Motor Tanker "JANKO"

Mr. W. E. Lee, Mr. G. Knowles, and Mr. S. Sedgwick, representing the Salvage Association, called at this office to discuss certain matters arising from the Secretary's letter of 5th March regarding the recommendations made at Falmouth by the Surveyors. They said the recommendations made in the letter places the Salvage Association in some difficulty, as their contract was to renew the ship to the original scantlings. These recommendations involved an increase in the weight of about 80 tons, which would reduce the earning capacity of the ship by about £1,000 per year, and might affect the stability. The Owners, in their opinion, might not be prepared to accept the ship with these disabilities. They decided, therefore, that the following question should be answered -

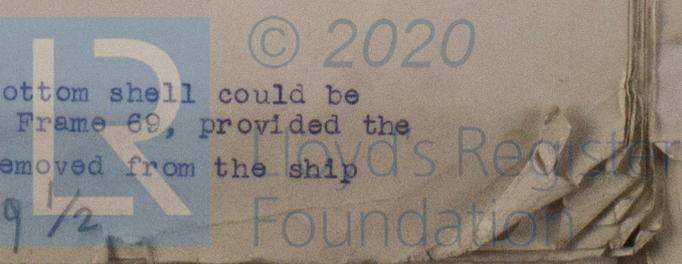
When renewing the structure forward of Frame 69, could the scarping of the side and bottom shell be made forward of Frame 69?

The scarping of the side and bottom shell could be effected in the tank forward of Frame 69, provided the tests now being made on steel removed from the ship

in way of the fracture show that the remaining material is of satisfactory quality. A plan should be submitted showing the proposals for scarphing.
